Addendum No.: 4

Date of Addendum: May 4, 2020

Prudence Crandall Museum Renovations  
1 South Canterbury Road  
Canterbury, CT  
BI – RR – 28

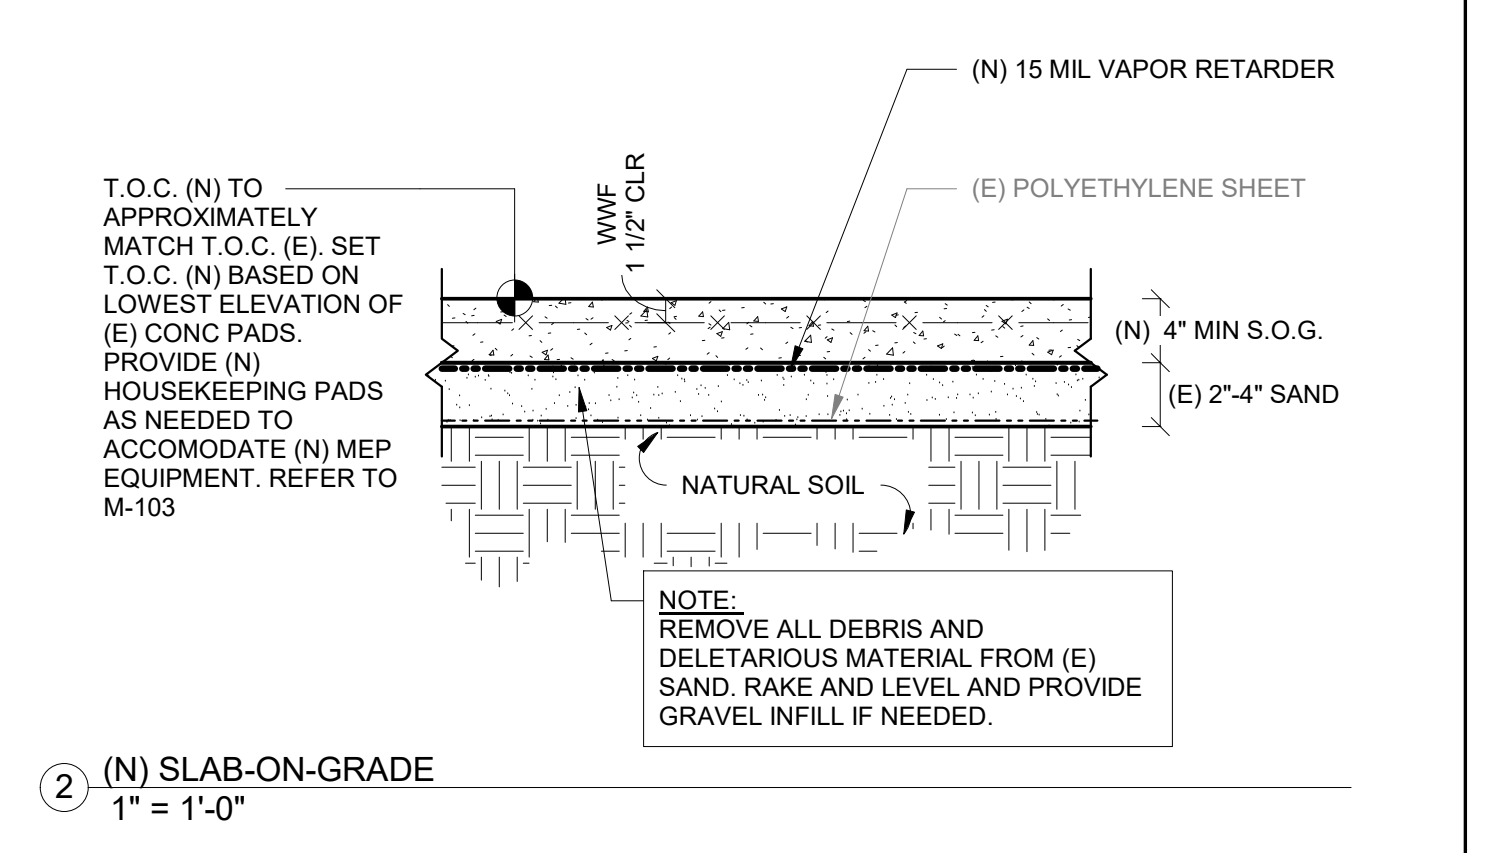
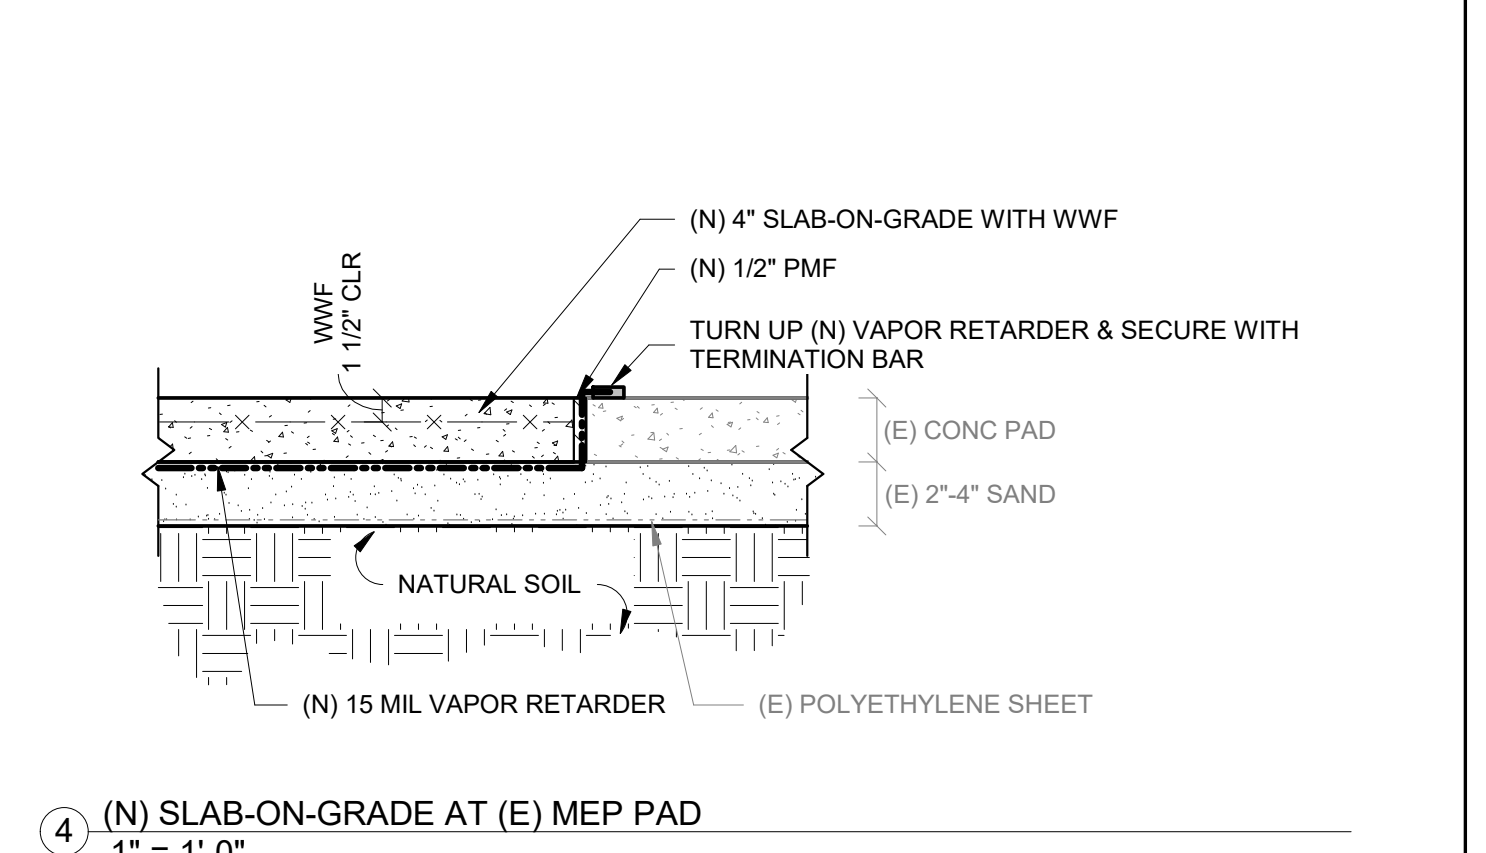
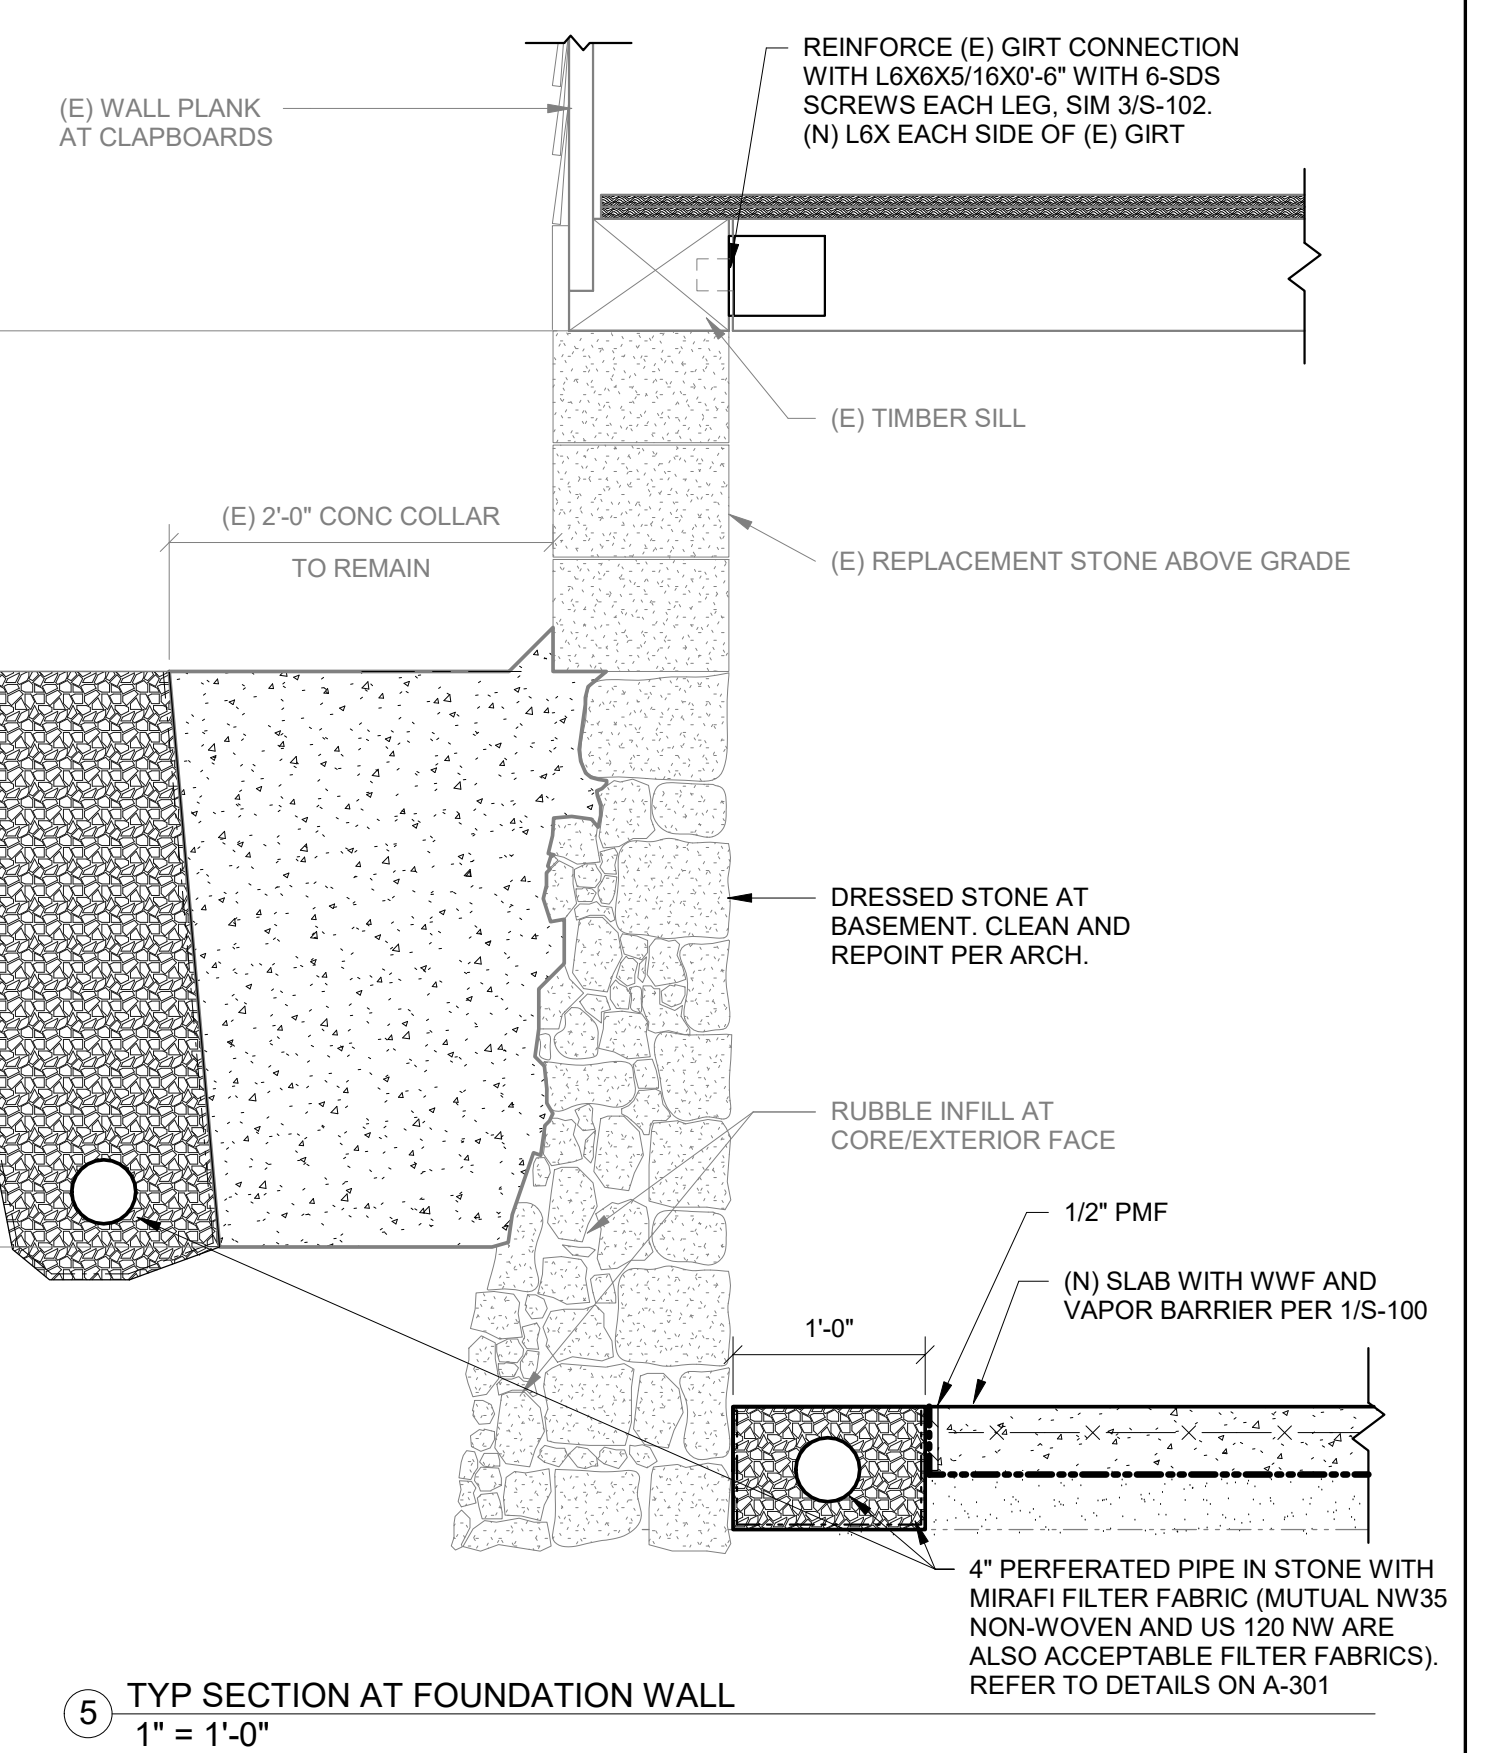
**Question 3:** *Drawing S-102 calls for a 3" pipe down at gridline E1. Drawing S-101 does not show a 3" pipe at E1. Drawing S-103 shows a representation of a pipe at E-1 with no call out. Please clarify if this pipe goes up or down, or both, or none?*

**RESPONSE:** Column should extend from ridge down to foundation. See revised structural drawings S-100, S-101, S-102, S-103, S-104, dated April 30, 2020, attached.
